Modification Application for Tweed Shire Council Depot (DA22/0793.02)

Review of Hydraulic Assessment

Rev B

February 2025

Figure 3-2 Example flood level hydrograph (20% AEP) for the South Murwillumbah basin adjacent to Focheong property (source: CSSE, 2024)

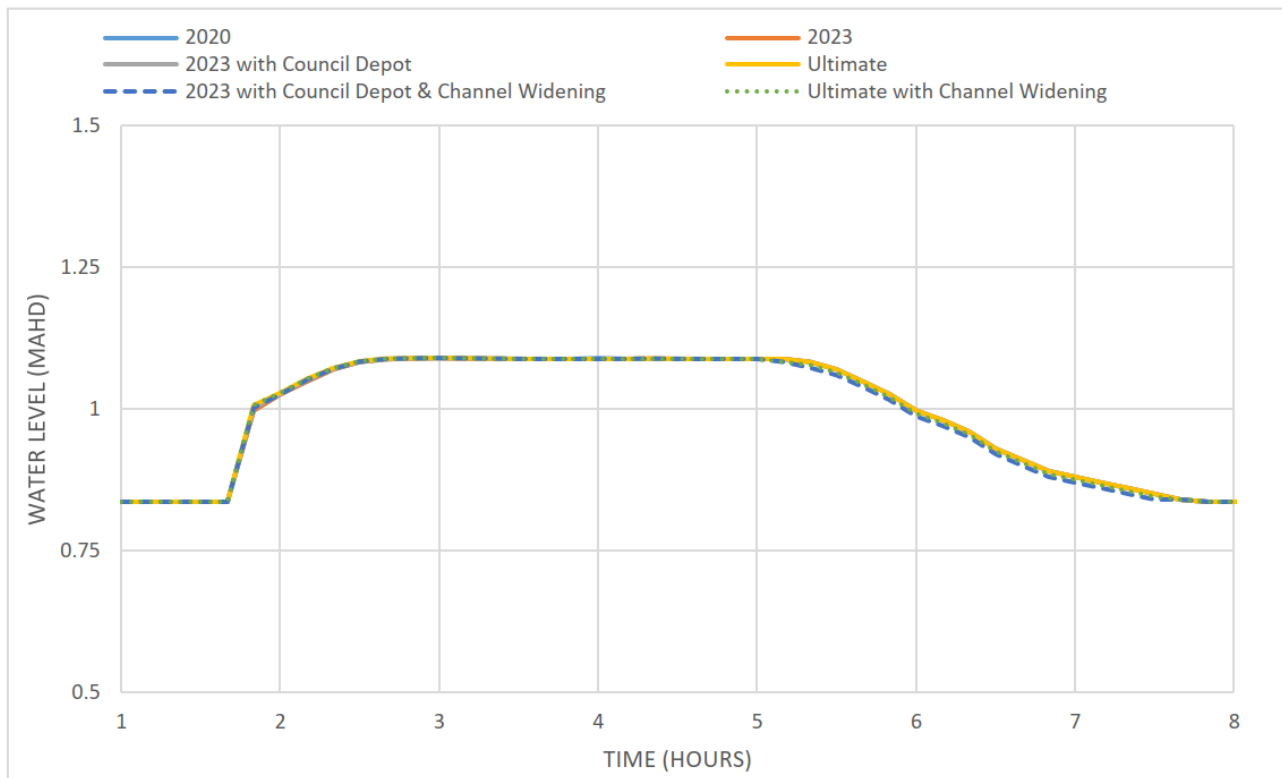
However, the flood level hydrographs provided in the CSSE report show that the Industry Central development scenarios (without OSD or mitigation) are not expected to significantly impact on the duration of flooding relative to the 2020 base line conditions (refer **Figure 3-2**).

Figure 5-1 Catchment area draining to the main drainage channel adjacent the Fochong property (adapted from CSSE, 2024)

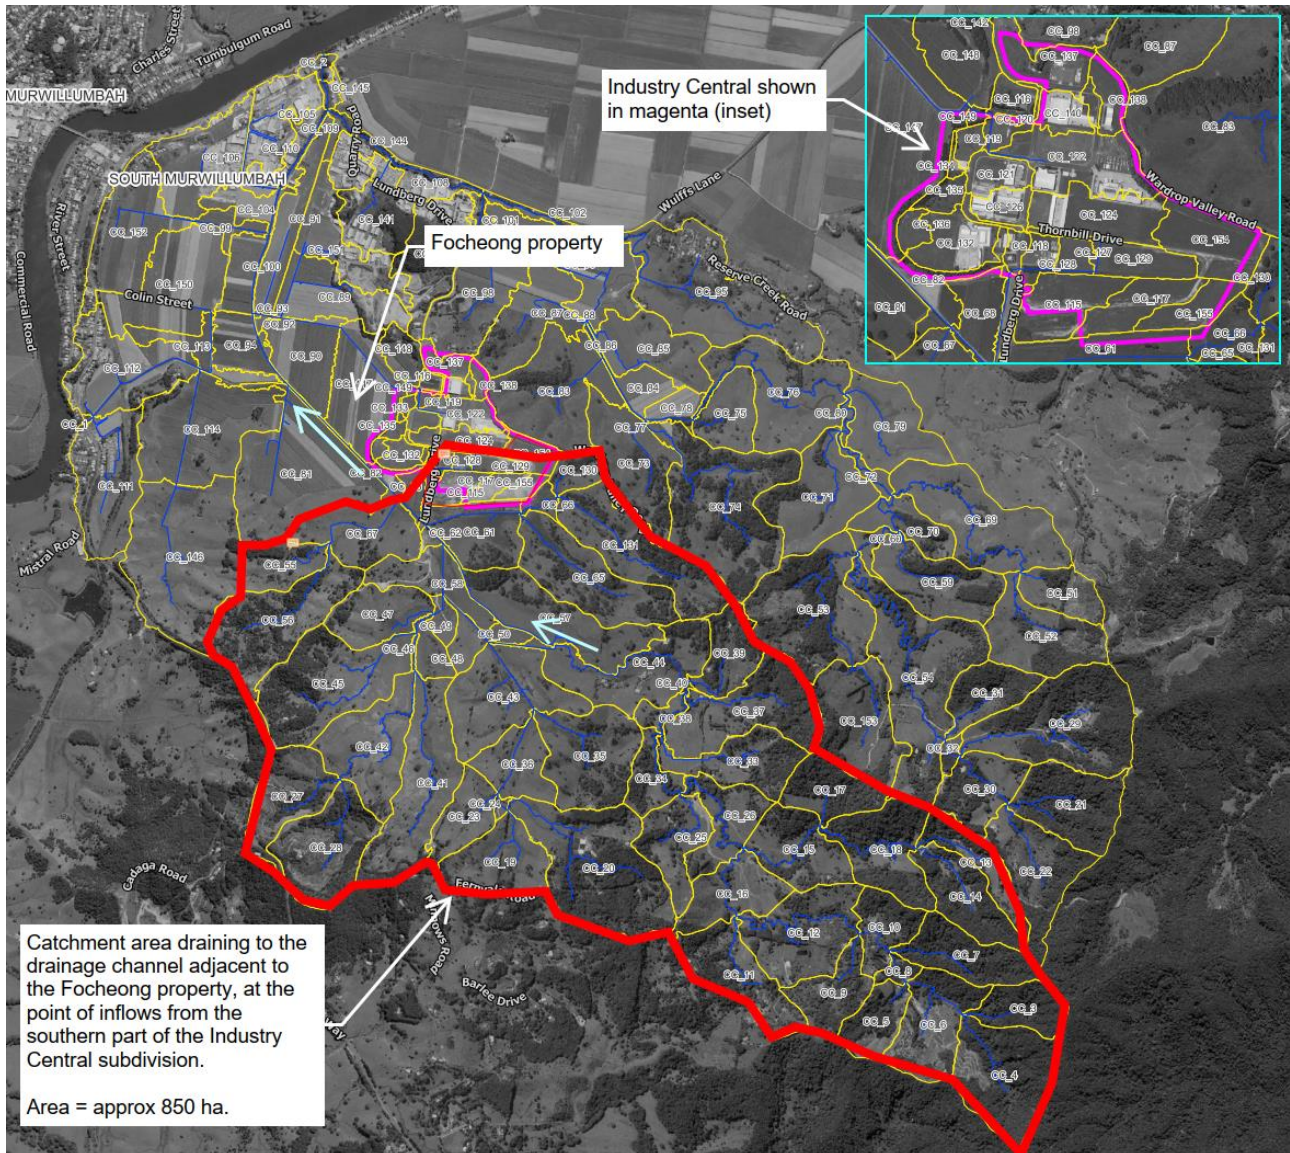
In response to the issue of broader catchment processes, it is noted that the main drainage channel passing the southern and western boundaries of the Fochiong property (refer Location 3 in **Figure 3-1**) has an upstream catchment area of approximately 850 hectares according to the catchment layout shown in the HA Report (refer **Figure 4-2**). This compares to an area of about 20 hectares for the southern/eastern part of Industry Central that drains to the same location, which represents less than 3% of the total catchment area. The depot site has an area of about 4 hectares, which represents about 0.5% of the total catchment area draining to Location 3.

Accordingly, the rainfall and resultant flows that lead to inundation across the low-lying Fochiong land are considered to be very much the result of broader catchment processes and cannot be unlinked from the flooding associated with those broader catchment processes.

This would apply in both rarer and more frequent storms. The runoff during smaller, more frequent storms across the 850-hectare upstream catchment would still need to pass along the main drainage channel beside the Fochiong property and would flow at a much greater rate than the rates of runoff discharging from Industry Central.

FIGURE A3

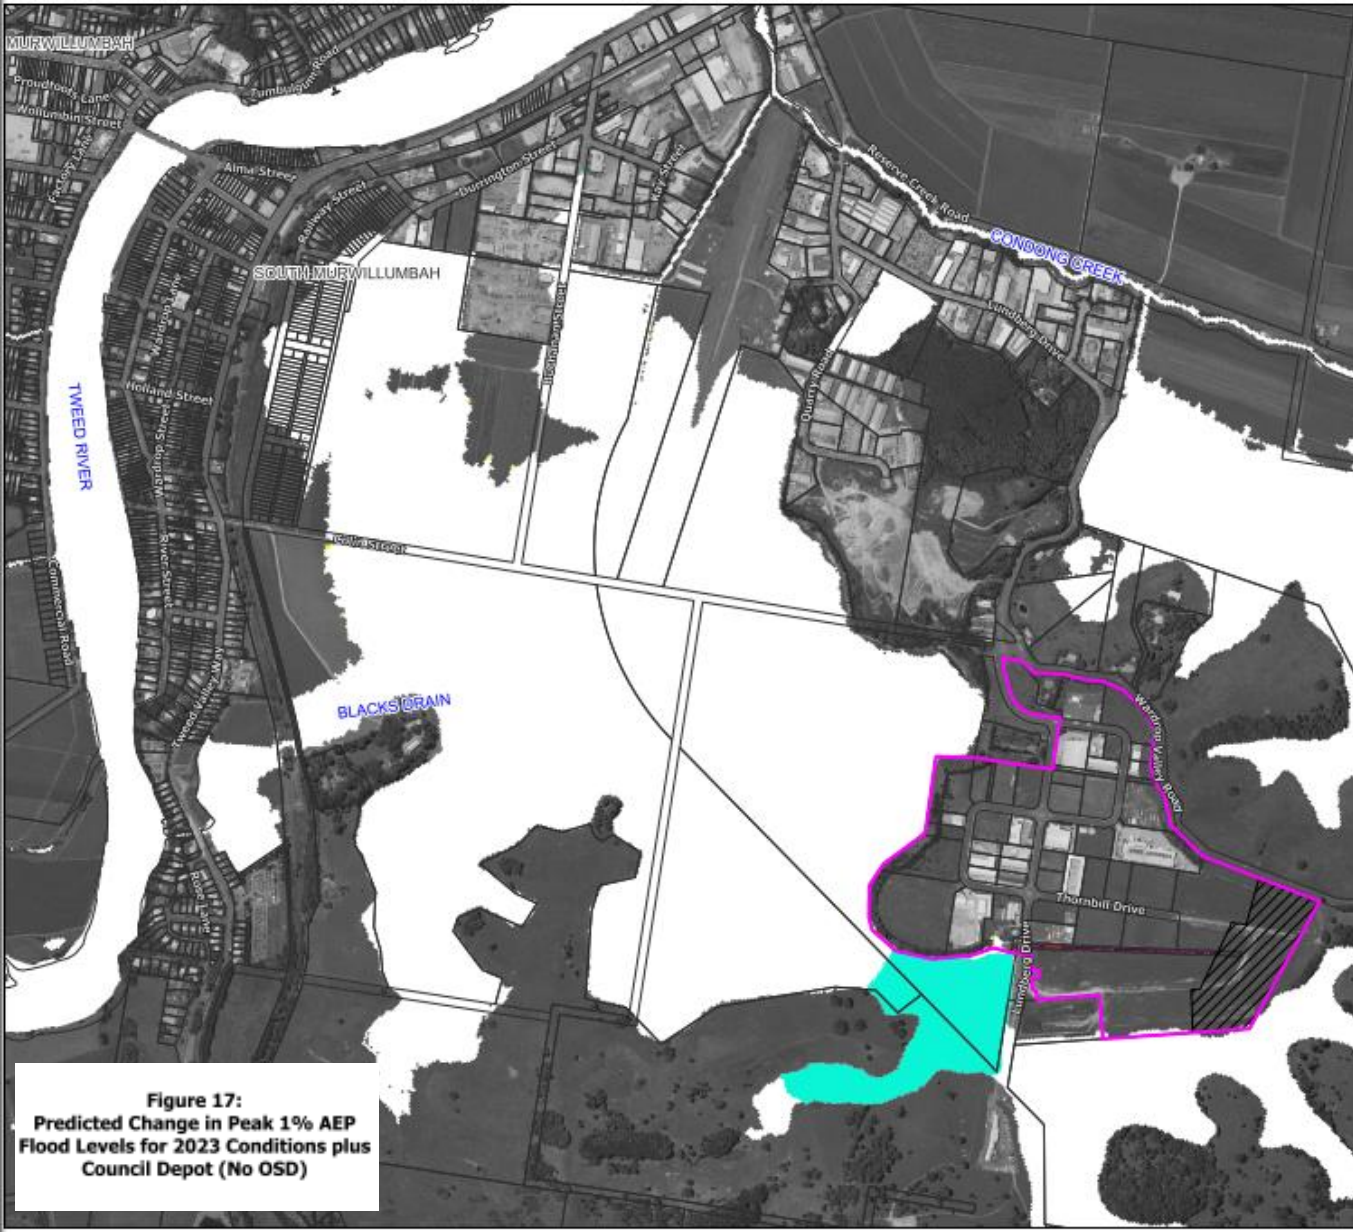
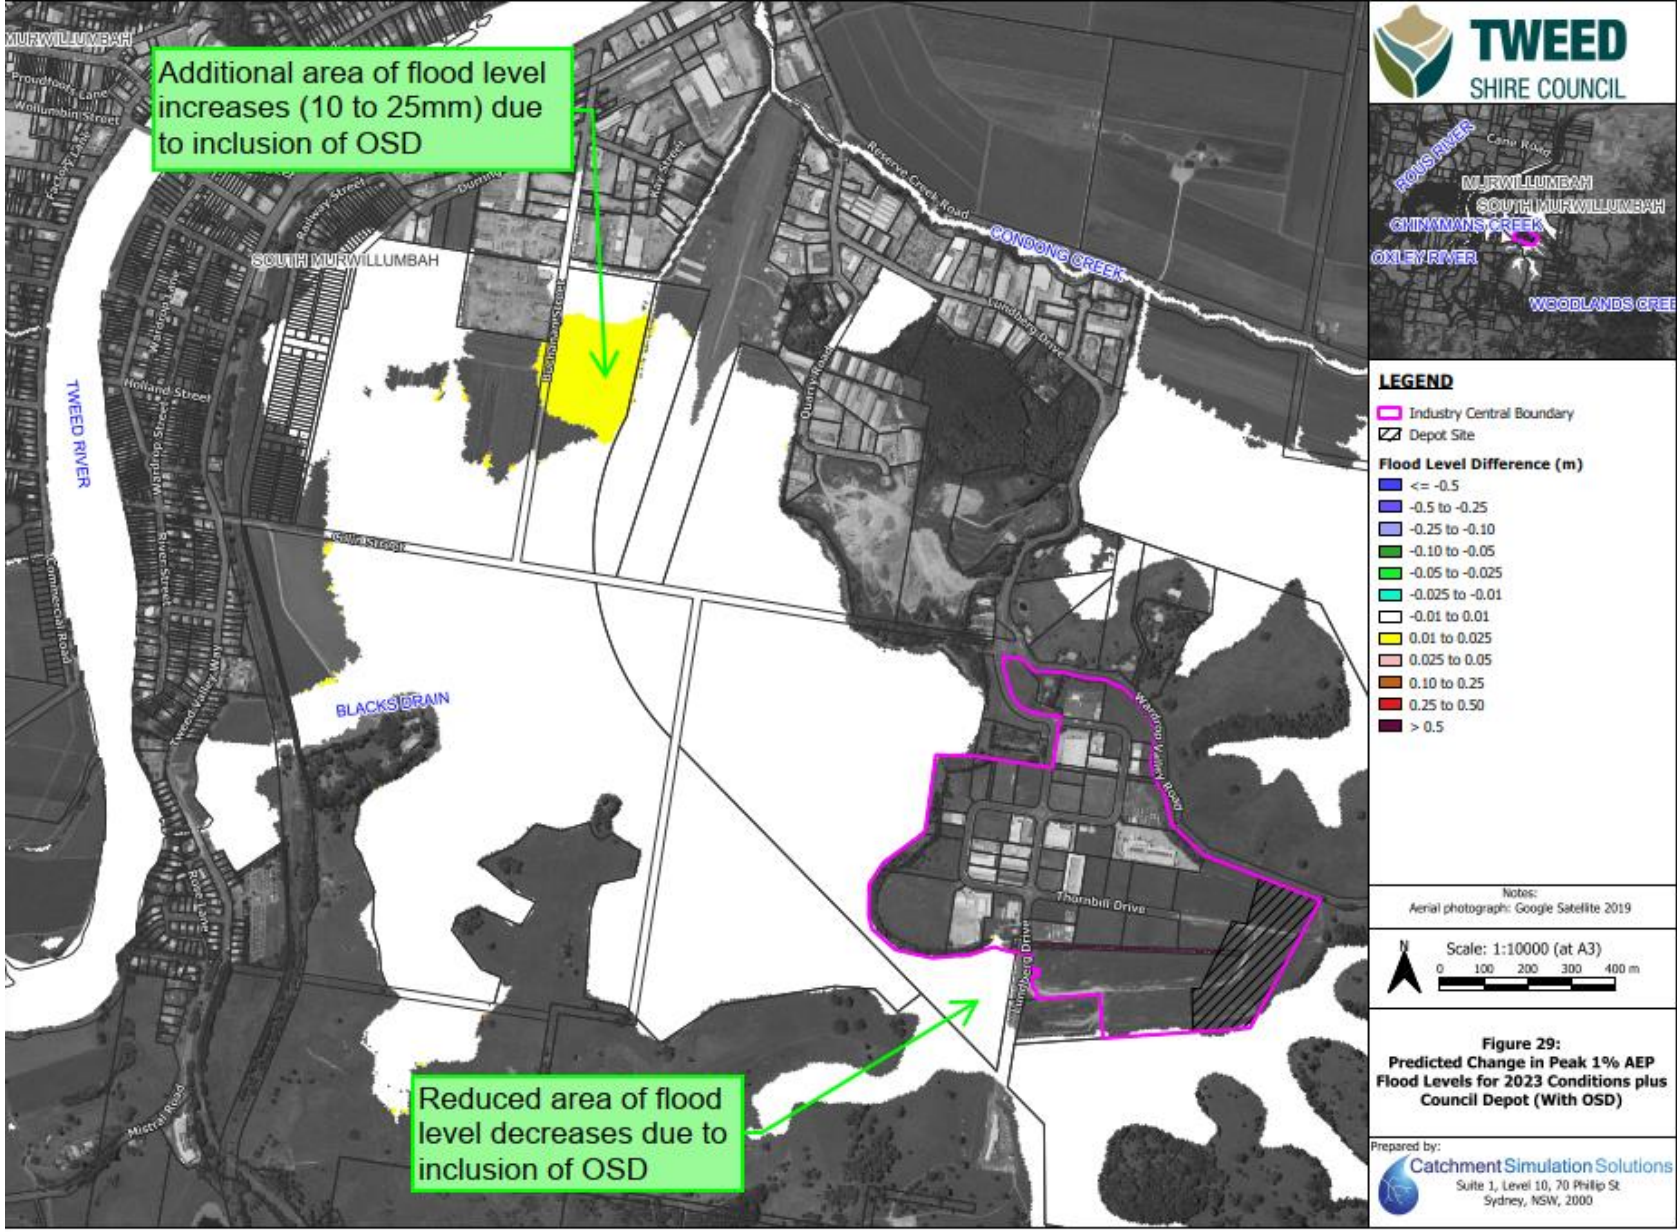
Some minor flood level increases are expected across the South Murwillumbah basin but these are not predicted from the modelling to exceed 10 mm (refer to the left side map on **Figures A1 to A3** in **Appendix A**). Some small, localised increases in flood level of up to 20 mm are expected around the periphery of the basin, which CSSE suggests are related to the increase in volume of runoff from the subdivision. These localised increases are difficult to see on the mapping in **Appendix A** given the areas affected are very small.

The difference mapping shows there is a decrease in peak flood levels expected across the floodplain to the south-west of Industry Central (refer light blue area on the left side maps in **Figures A1 to A3** in **Appendix A**). CSSE indicates these decreases are typically about 10 mm.

FIGURE A4

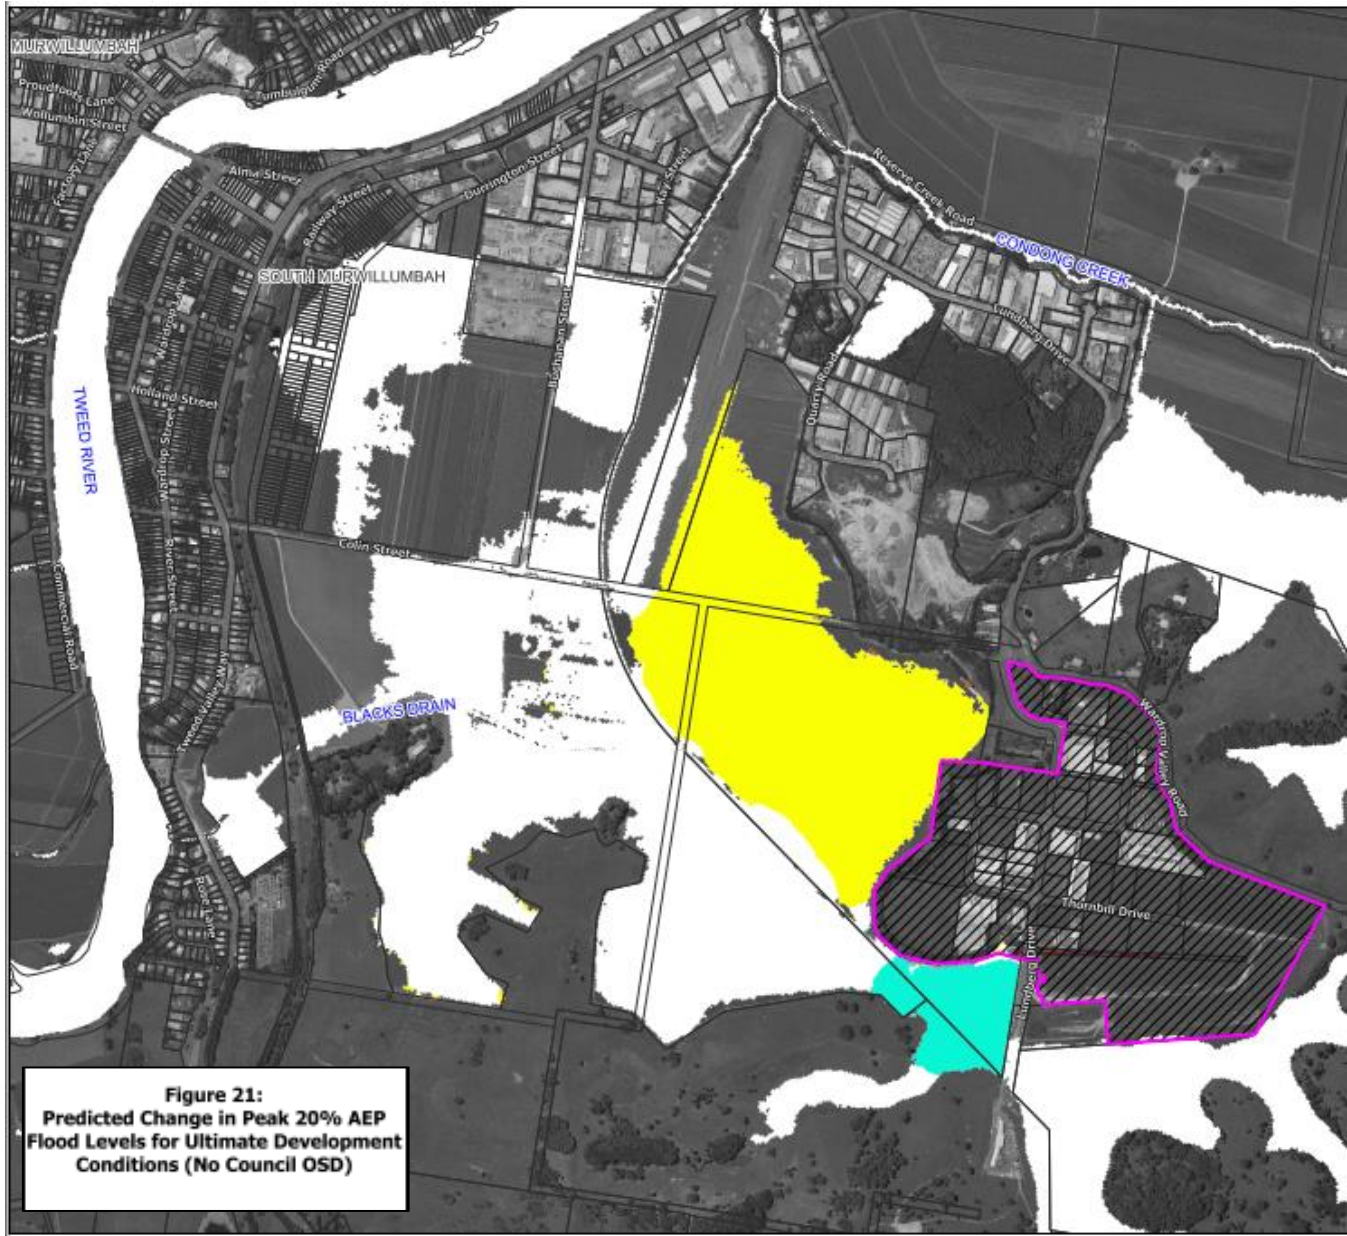
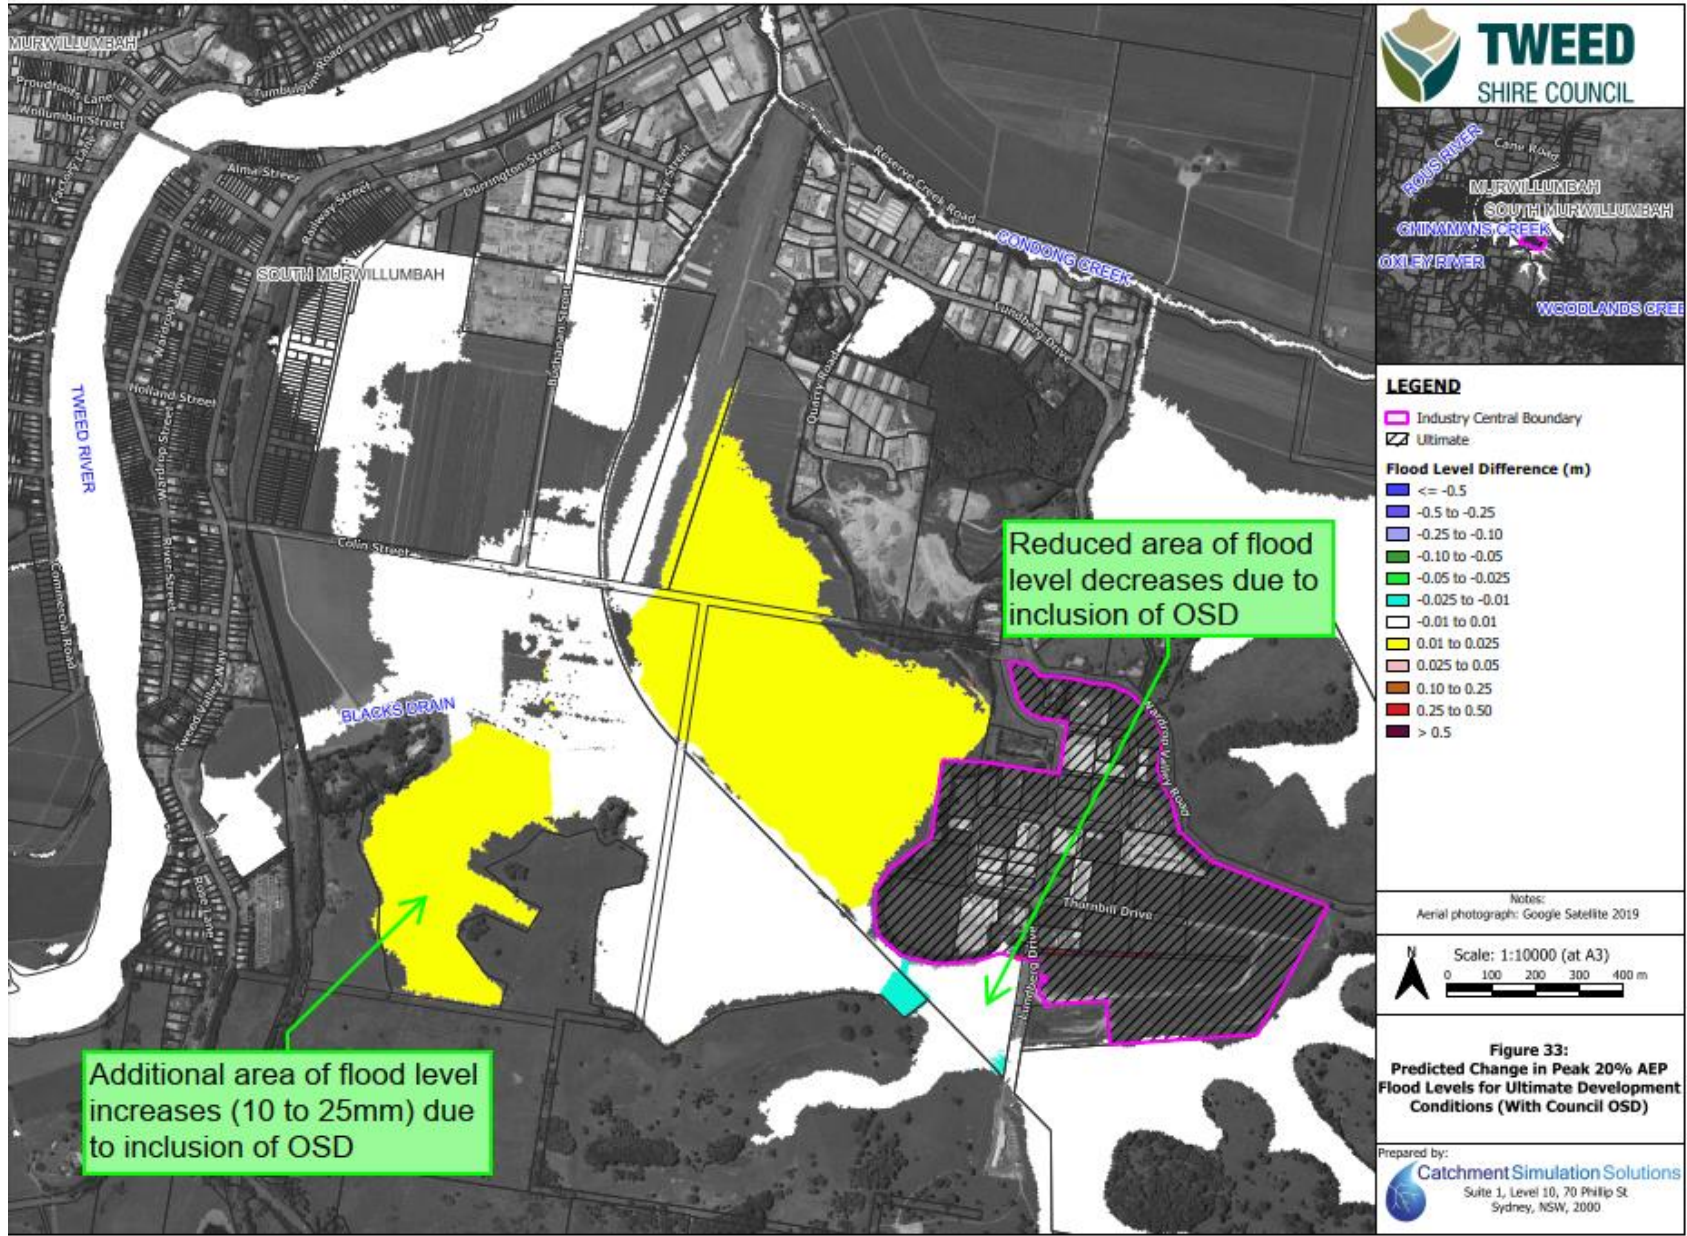
floodplain during the 20% AEP event (refer yellow area in left side map in **Figure A4** in **Appendix A**). However, during the 5% and 1% AEP events any flood level increases beyond 10 mm are limited to very localised areas at the edge of the basin.

Assessment of the ultimate development scenario indicates that there will be a 10 to 25 mm decrease in peak flood levels across the floodplain to the south-west of Industry Central (refer light blue area on the left side maps in **Figures A4 to A6** in **Appendix A**).

However, the green labels included in **Figures A1 to A6** (refer **Appendix A**) identify the additional areas across the wider floodplain where incorporation of OSD at the Council depot is expected to increase flood levels by between 10 and 25 mm, for both 2023 conditions and the ultimate development scenario.
